This document is submitted to the Department of Planning, Housing and Infrastructure (DPHI) in support of the Response to Submissions (RTS) to the State Significant Development Application (SSDA) (SSD-94006708) for a mixed use development at 15-21 Cottonwood Crescent, Macquarie Park.

The Proponent has received feedback from the Department of Planning, Housing and Infrastructure (**DPHI**), Transport for NSW (**TfNSW**) and City of Ryde Council (**Council**), following the submission of the transport impact assessment report as part of the EIS submission. The responses are identified and references are provided to show where they are addressed in this document.

APPENDIX A – UPDATED SWEEP PATH ANALYSIS

8.800m
2.500m
3.633m
0.428m
2.500m
4.00 sec
10.000m

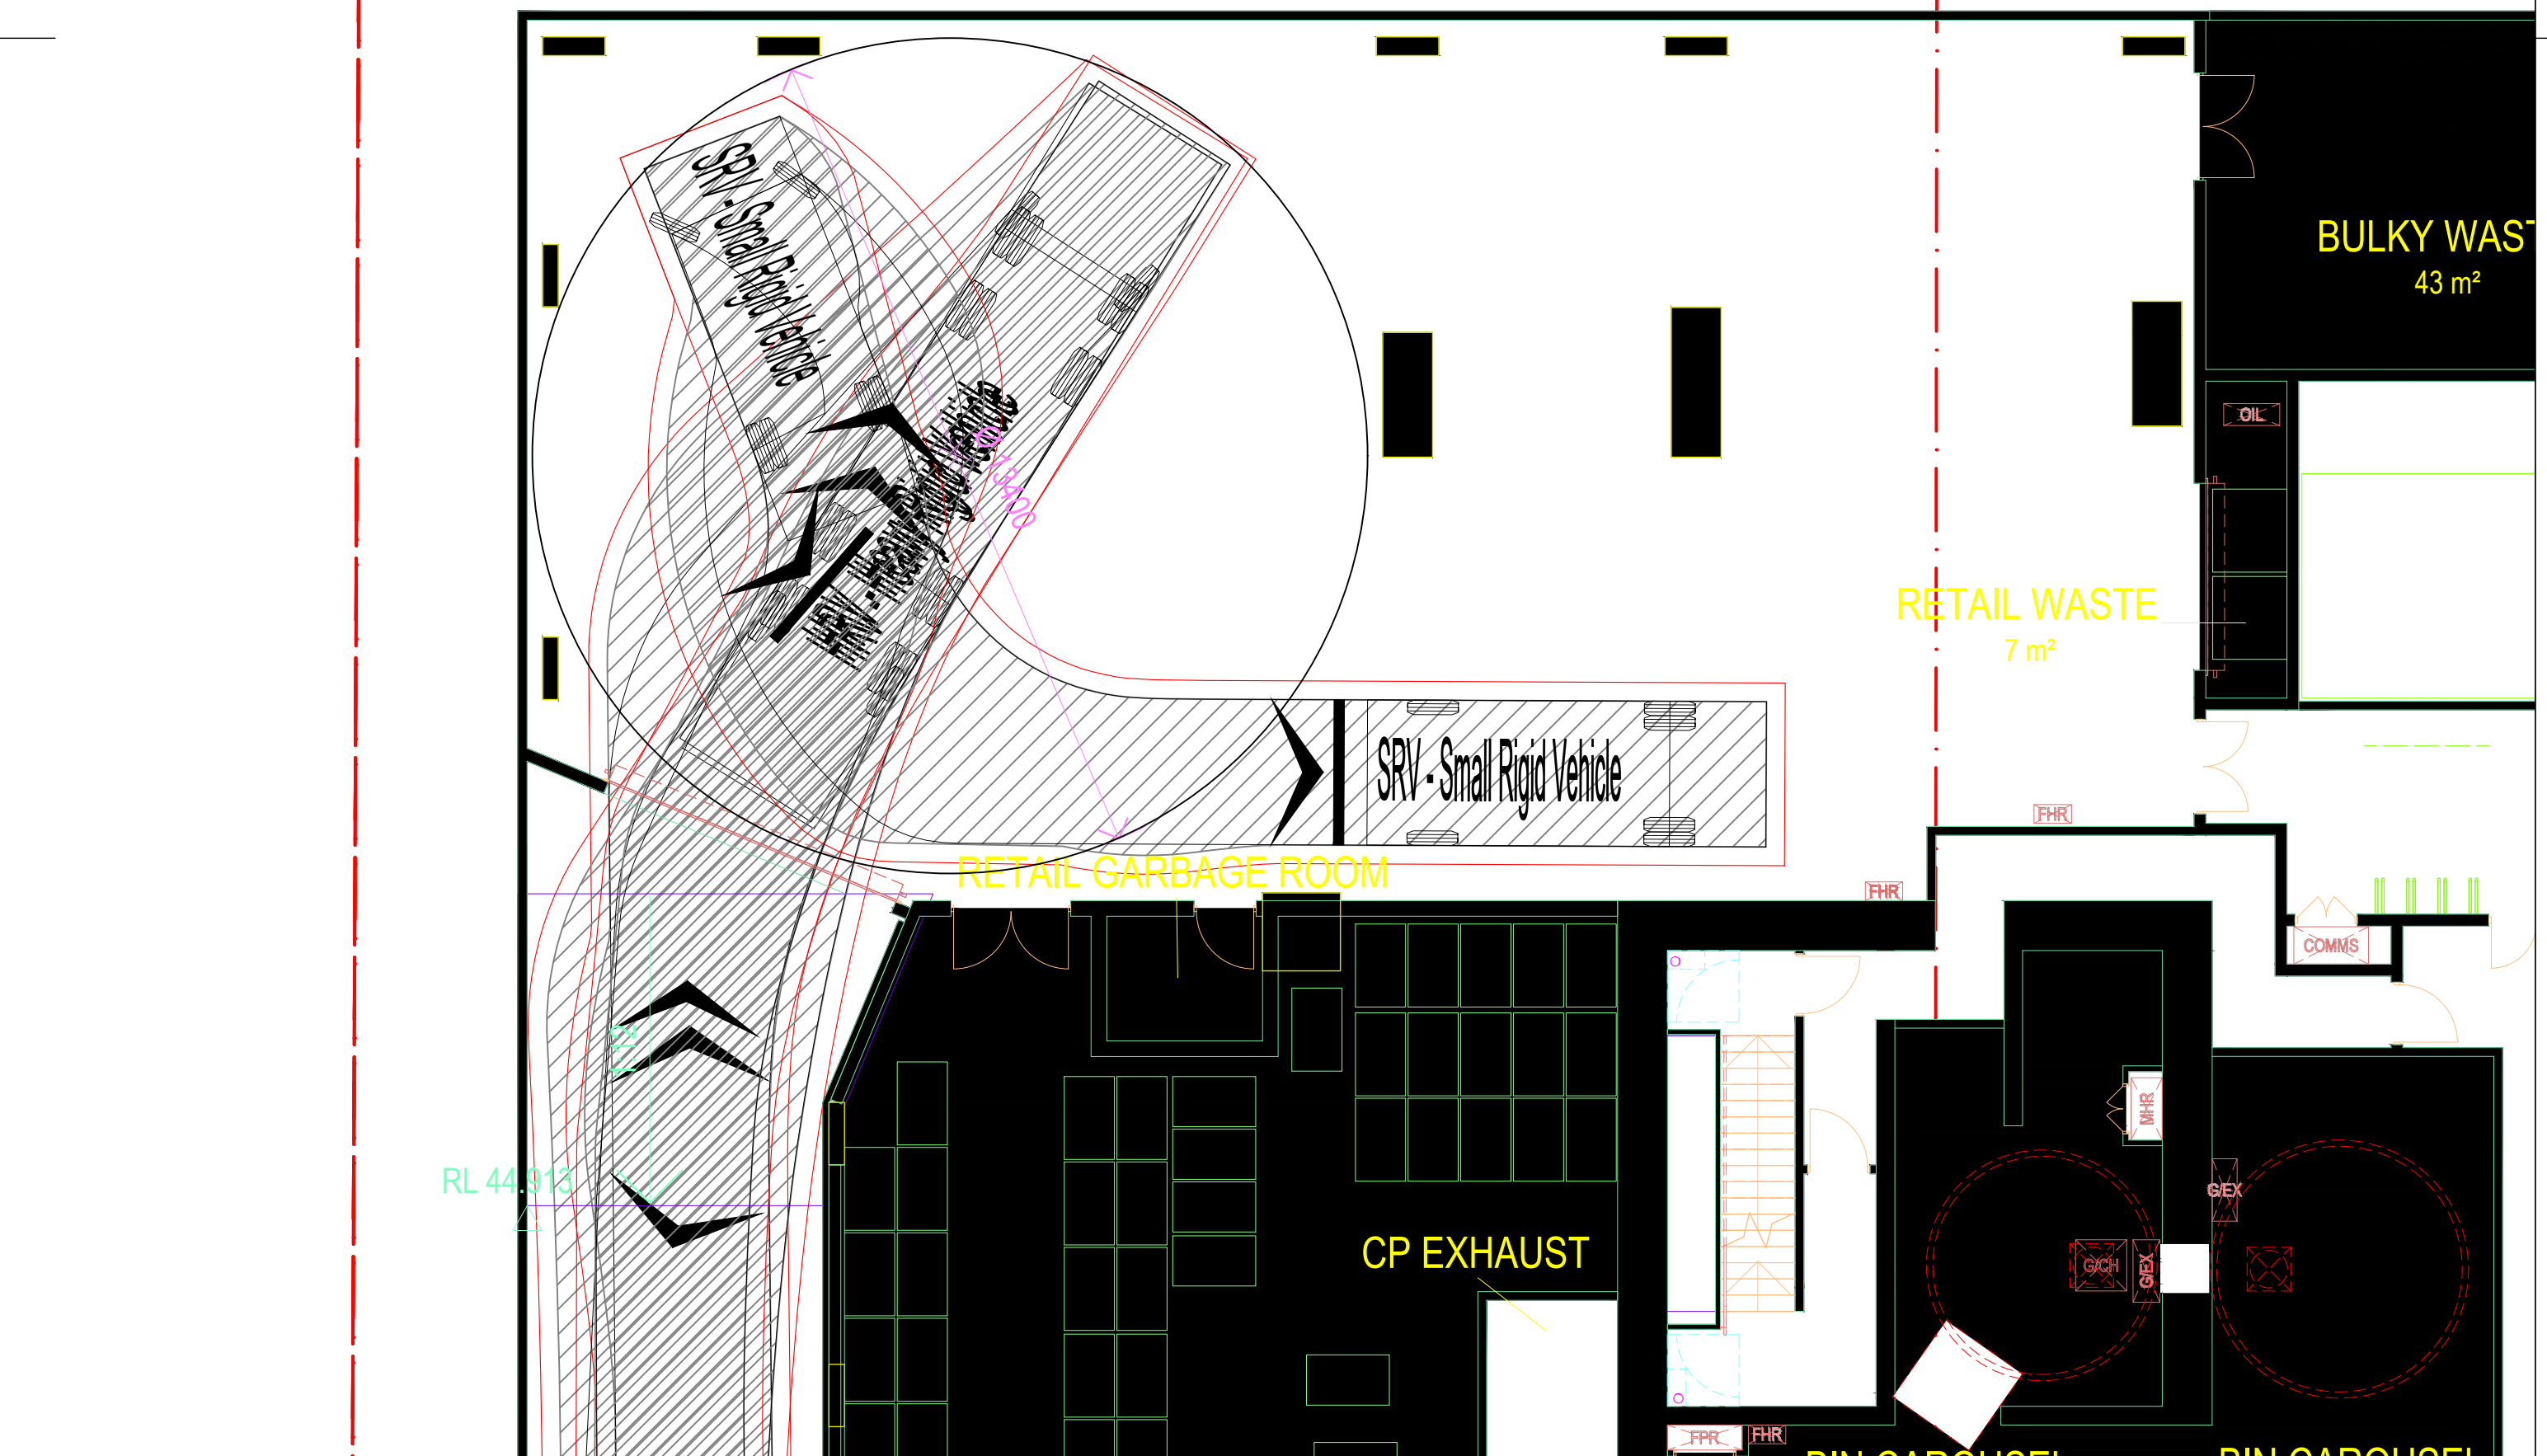
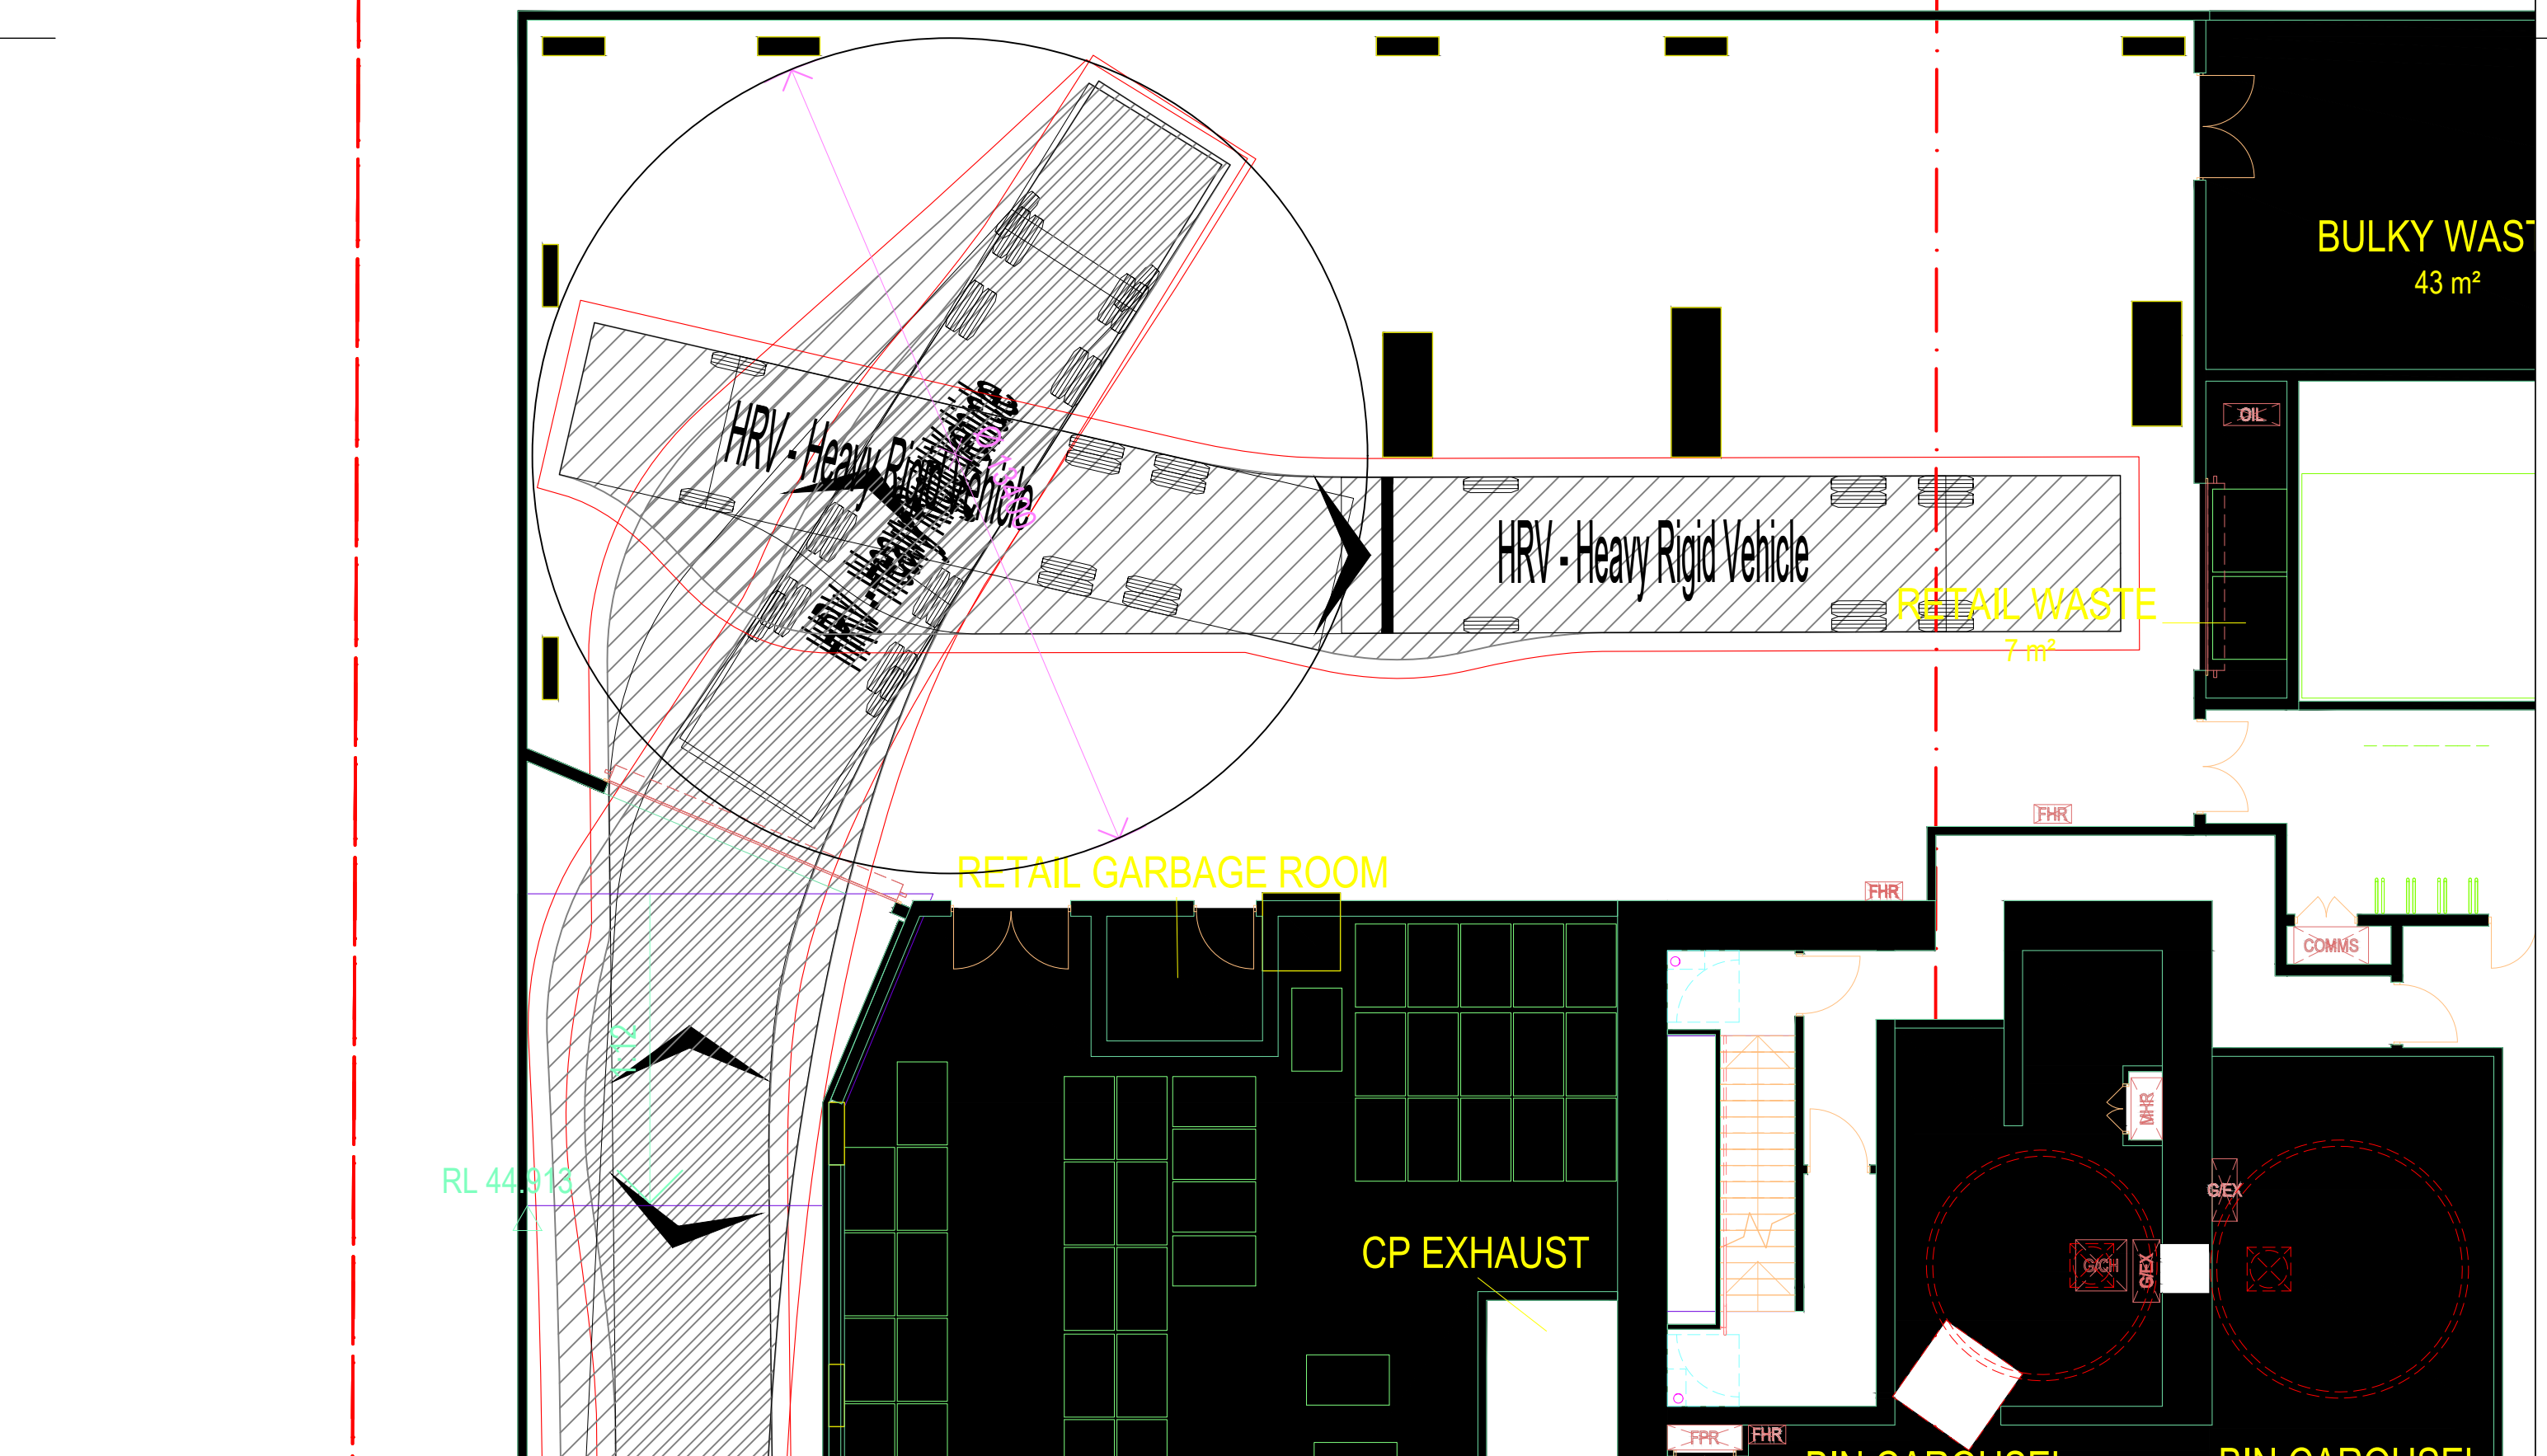
Agency	Agency Comment	JMT Consulting Response
Council – Waste Management	Provide swept paths for a heavy rigid vehicle in accordance with AS 2890.02 to ensure waste collection vehicles can safely access the site for servicing. - The swept paths provided cannot be used to clearly identify the proposed transit of the 12.5 metre HRV utilised for waste collection. Swept paths must be clearly identified for each vehicle type. - The paths detailed in the Traffic Impact Assessment do not clearly show the vehicle body therefore conflicts cannot be determined. - The provided swept paths do not clearly demonstrate whether the proposed turntable is unobstructed from bins doors, or support structures. This space must remain clear of all obstructions to support safe and efficient servicing.	Full scale swept path plans are provided in Appendix A of this document, including for a 12.5m HRV utilised for waste collection. The swept paths include both the vehicle body and clearance envelope as required under AS2890.2. The swept paths confirm that the proposed turntable is unobstructed from bins doors, or support structures.
